Norwest Bank - North Avenue  
2808 North Avenue  
Grand Junction, CO 81501

# REVIEW COMMENTS

FILE #SPR-96-235

TITLE HEADING: Parking Lot

D.F. ILLUMINATED DISPLAY 1=1'-0"

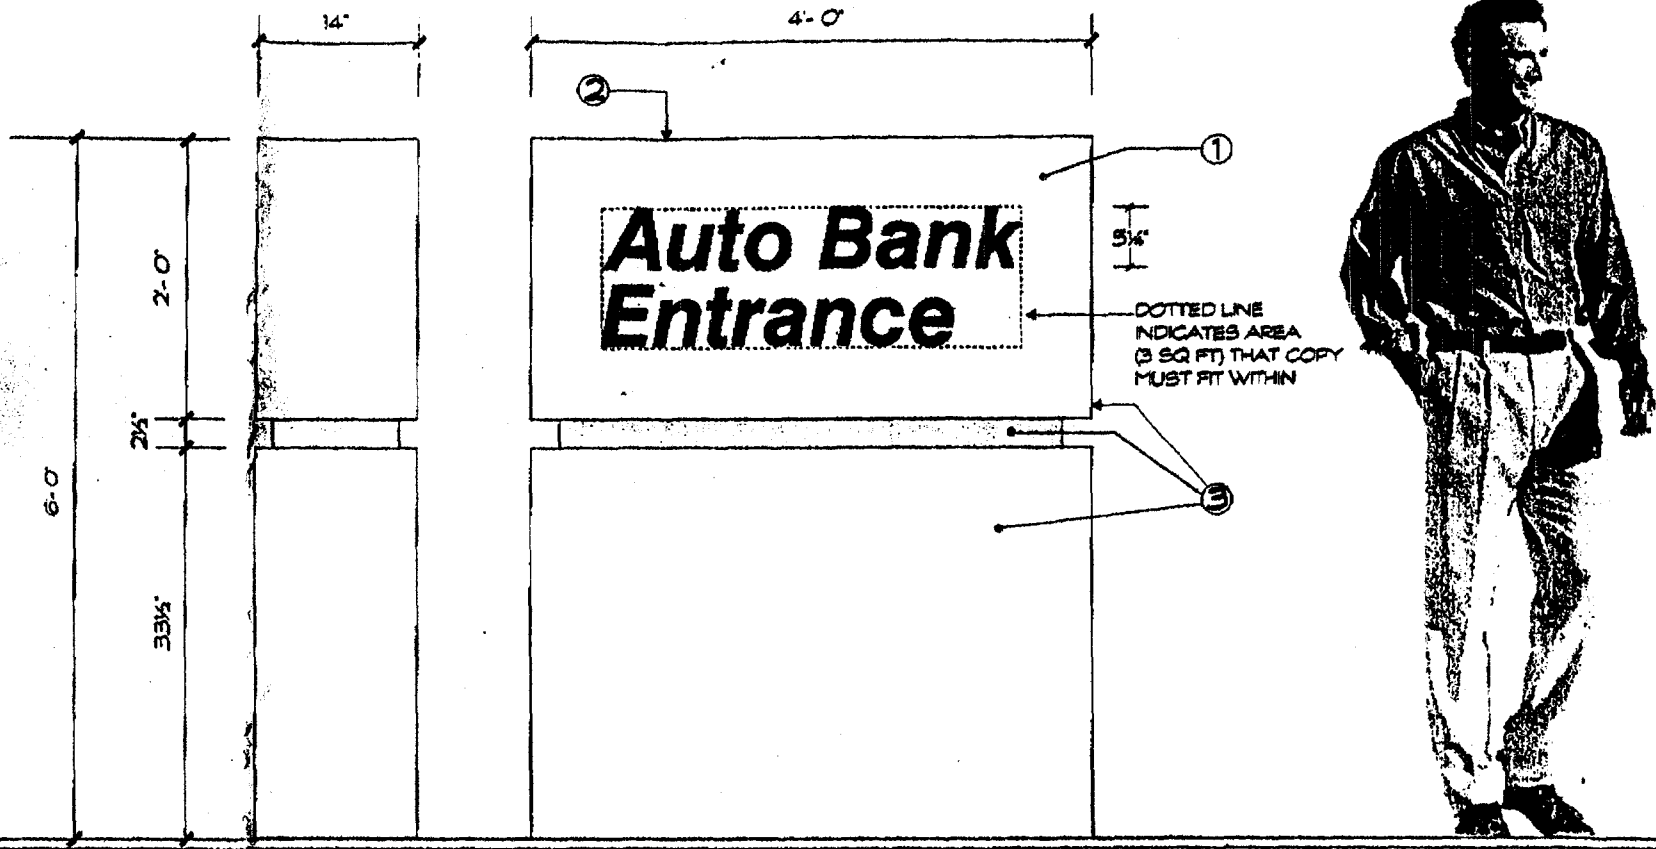
We have reduced the copy area  
to 3 square feet and taken off  
Norwest Bank's name.

Please let me know as soon  
as you can if this is OK.  
also do we need a permit how  
that the sign is three square  
feet?
